[Docket No. 2002-SW-46-AD; Amendment 39-12910; AD 2002-21-04]

Airworthiness Directives; Agusta S.p.A. Model A119 Helicopters

ACTION: Final rule; request for comments.

FIGURE 1

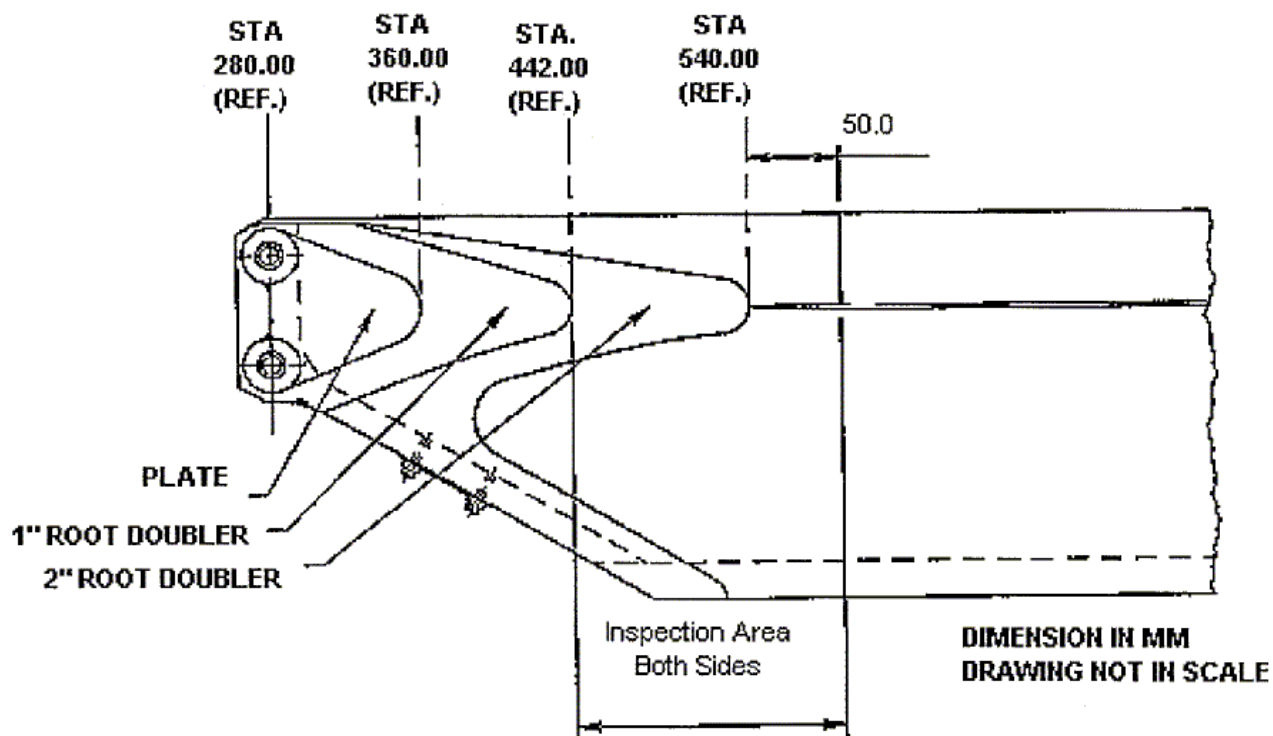
(b) Before each start of the helicopter engine, visually check both sides of each tail rotor blade for a crack in the area depicted in Figure 1 of this AD. An owner/operator (pilot) holding at least a private pilot certificate may perform this visual check and must enter compliance with this paragraph into the aircraft maintenance records in accordance with 14 CFR 43.11 and 91.417(a)(2)(v). See Figure 1:

Note 2: Paint irregularities on the tail rotor blade may be due to a crack.
